03 April 2025

Our Ref: SYD224_109-5 (ACCESS) RT

ACCESSIBILITY CAPABILITY STATEMENT FOR REF LODGEMENT PROJECT NAME: MILTON PUBLIC SCHOOL UPGRADE 9 THOMAS STREET, MILTON NSW 2538

Figure 2 Site Plan [Source: Fulton Trotter, 2025]

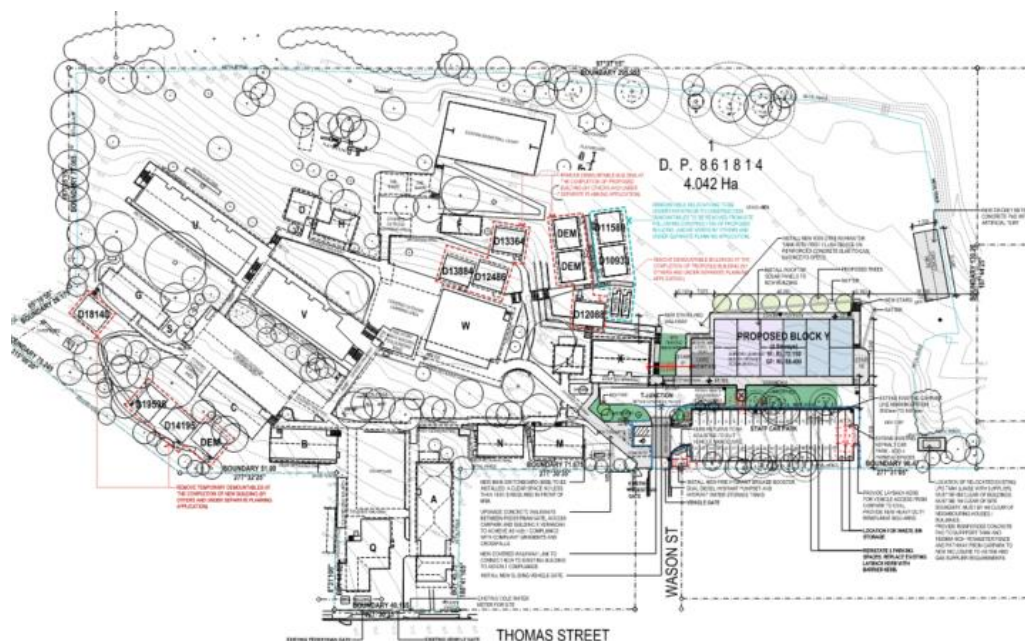
ITEM	PROPOSED PERFORMANCE SOLUTION	BCA DtS CLAUSE	PERFORMANCE REQUIREMENT
1.	Accessway from pedestrian entrance at Thomas Street along the allotment boundary to the new building entrance with existing AS1428.1 shortfalls will not be an accessible entrance. Directional signage will be required to direct pedestrians to the upgraded accessible entrance.	D4D3	D4P1 & D4P2
2.	Staff only accessible and ambulant facilities not available within the new Block Y.	F4D5, F4D6	F4P1

BCA CLAUSE	STATUTORY REQUIREMENT	ASSESSMENT
		the accessible carspace to the new building will be compliant with AS1428.1. In addition the path from Wason Street pedestrian entrance may require modifications to bring up to current AS1428.1 standards. Further details will be required to support the Performance Solution Report including transport options both school services and external services. An accessway is to be provided between the new Building and the nearest accessible building being Building X by a compliant AS1428.1 accessway. The existing slope that does not appear to comply should be upgraded within the scope of works. An accessway is required from the upgraded existing accessible carspace located near the new building, to the entrance doors of the new building compliant with AS1428.1. Details to be confirmed in detailed design documentation. Where any barriers/gates are provided along the accessible path of travel, these should be compliant with AS1428.1 door circulation clearances and be accessible at all times. The accessible carparking space shall comply with AS2890.6:2009 and all gradients to be confirmed to ensure compliance.
